Contractor Name: Building Name
LSE-1 Correction Calculator:

LSE-A-XXX Drawing	Type of Change			EXAMPLE: Where? Each Unit Needing 1 Hr Fire Rated Chase Repairs.
sheet #	view #	dim changed	deleted	
				X

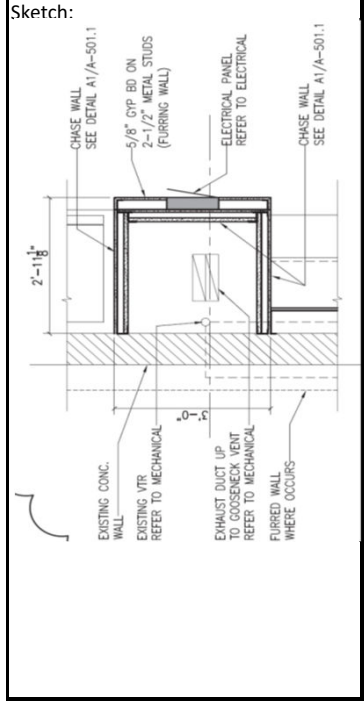
Change ==> **ADDED NOTE; CHASE IN KITCHEN; SEE DETAIL C1/A-501.1**

\$ 50,754.89	Total for All Affected Units					
Detailed Description	QTY	Materials \$	Unit	Hrs	Trade	TOTAL MAT
Materials and Methods Are To Comply with UL						
STEEL 'C' STUD52-1/2" 25 GA.	4	\$ 15.00	EACH			\$ 60.00
ADDITIONAL 5/8" GYP	1	\$ 30.00	4*8 SHEET			\$ 30.00
FASTENERS	1	\$ 15.00	LOT			\$ 15.00
						\$ -
NOTE: ALL CHASES ARE REQUIRED TO BE FIRE PROTECTED CONSTRUCTION; ANY PENETRATIONS PERFORMED BY OTHERS AFTER ORIGINAL CONSTRUCTION HAVE TO BE RE-CONSTRUCTED - FIRE RATED ASSEMBLIES CANNOT BE 'PATCHED' AND MAINTAIN THEIR PROPER FIRE RATING(S).						
PAINTER FINISH				1.5	PAINTER	\$ 96.83
DRY WALL FILL SAND AND SMOOTH				1	DRYWALLER	\$ 67.11
CARPENTER				3	CARPENTER	\$ 200.58
LABORER - HELPER				2	LABORER 1	\$ 107.52
SUPERVISE LAYOUT				1	SUPERVISOR
